RE: 181 Forest Way, Belrose – your ref. DA-217-02703-S4.55-1

Re: Lot 3 DP 805710, 181 Forest Way Belrose (subject site)

Suggested Amendments to the Bushfire Safety Authority

Figure 4: Current Site Plan (Morrison Design Partnership Architects. Project no. 3169, dwg no. DA050, dated 2022.04.05)

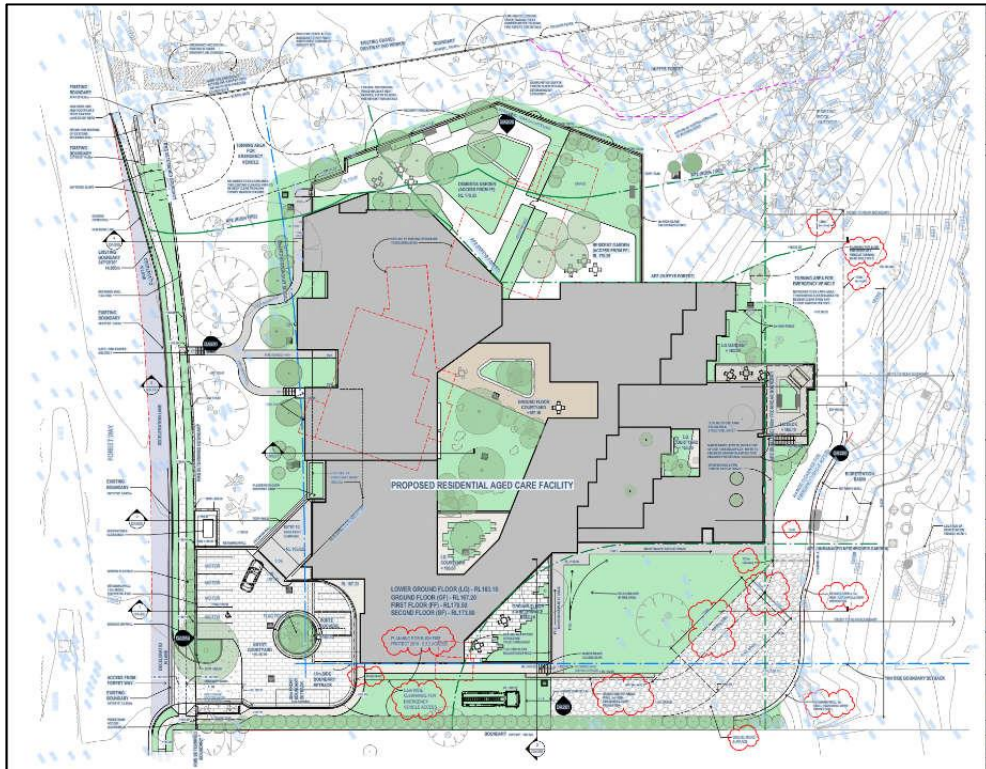
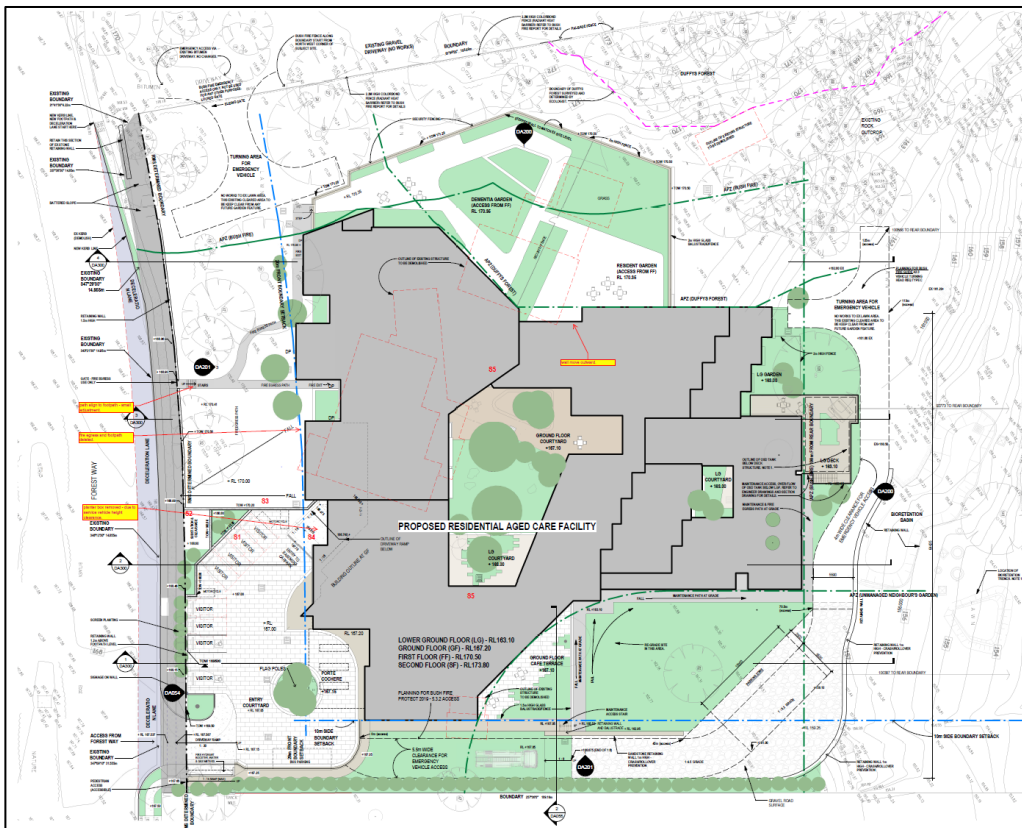
- Carpark access ramp and at grade parking within the Forest Way setback.
- Increase in car parking spaces from 45 to 49
- Lower ground floor – building footprint increases and sunken courtyard size has been reduced and location adjusted. This does not extend towards the hazard and maintains compliance with the approved APZ's
- Ground & first floor – building footprint increases towards the internal courtyard. This does not extend any closer to the hazard than adjoining walls and maintains compliance with the approved APZ's as depicted below.

As outlined above, the proposed amendment to the court approved development is minor in nature, does not encroach within the approved asset protection zone and will have no impact on the bushfire protection measures approved as part of the court approval. Suggested amendments to the bushfire safety authority are provided attached.

Figure 5: First Floor Plan. Source: Morrison Design Partnership Architects. Project no. 3169, dwg no. DA103, Revision 0, dated 20220405

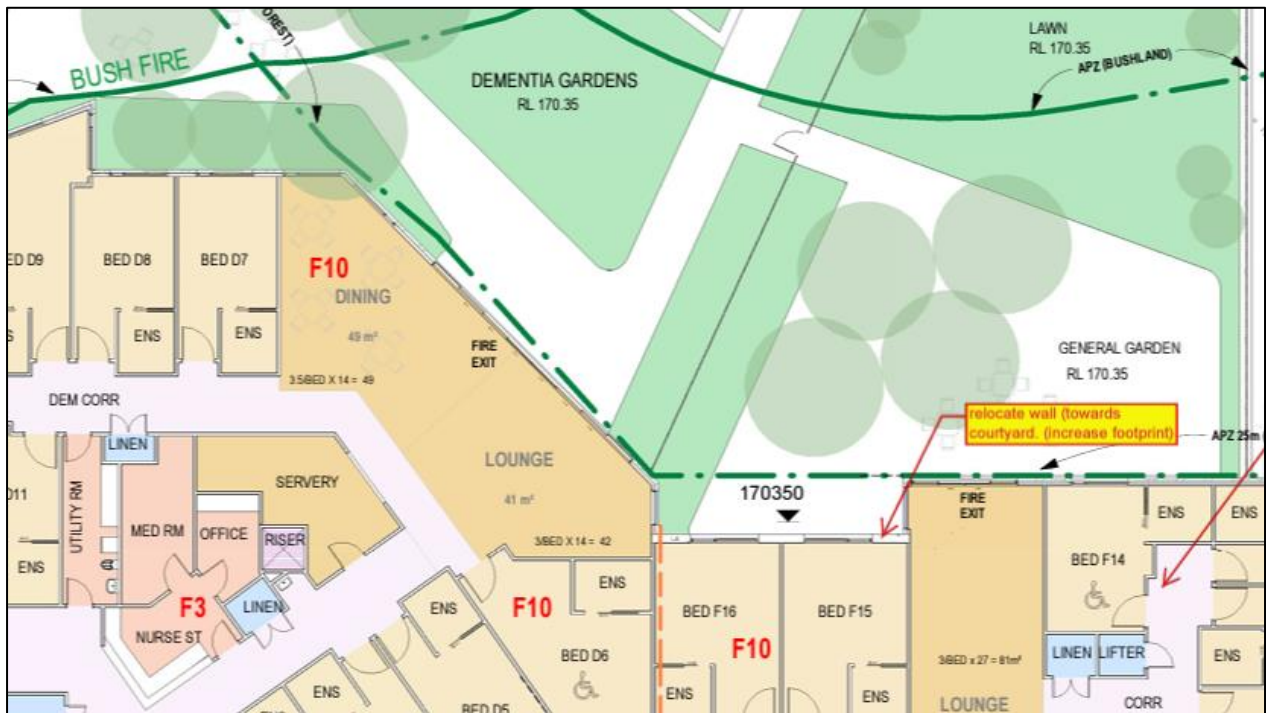
Figure showing minor amendment of footprint to the north whilst maintain compliance with APZ setbacks.
